20210826 V1.1:

Sheet: /
File: OpenThermMonitorTwomes.sch

Title: OpenTherm Monitor Twomes

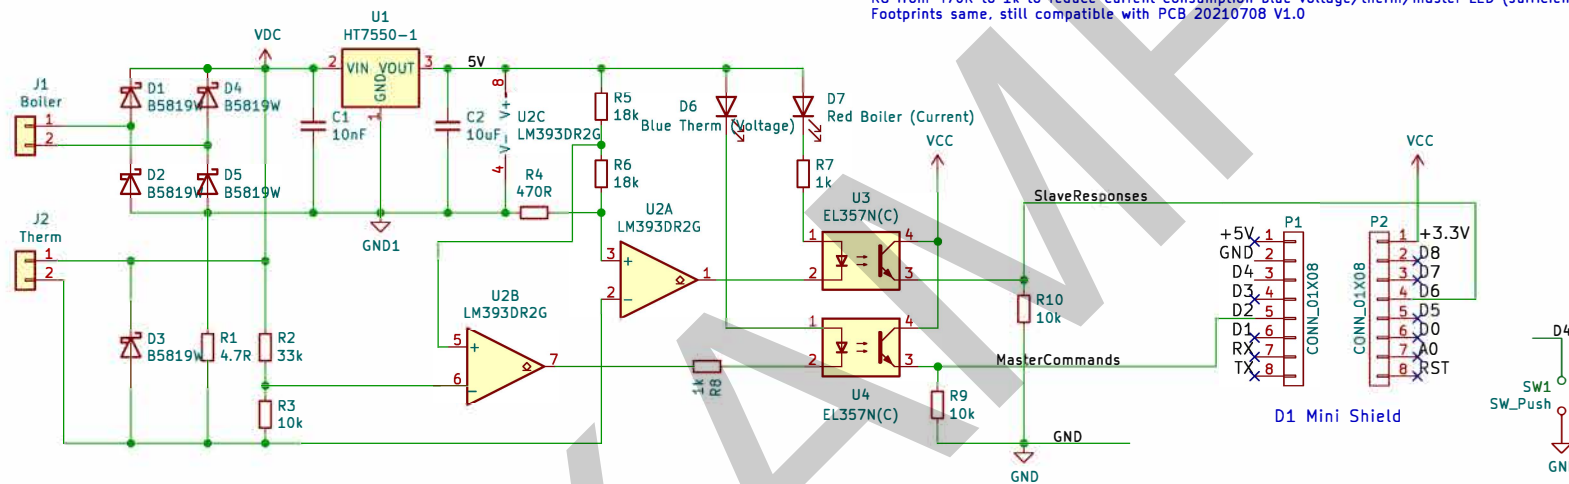
C1 from 100 nF to 10 nF to reduce rise time of VDC

R8 from 470R to 1k to reduce current consumption blue voltage/therm/master LED (sufficient for EL357NC)

Footprints same, still compatible with PCB 20210708 V1.0
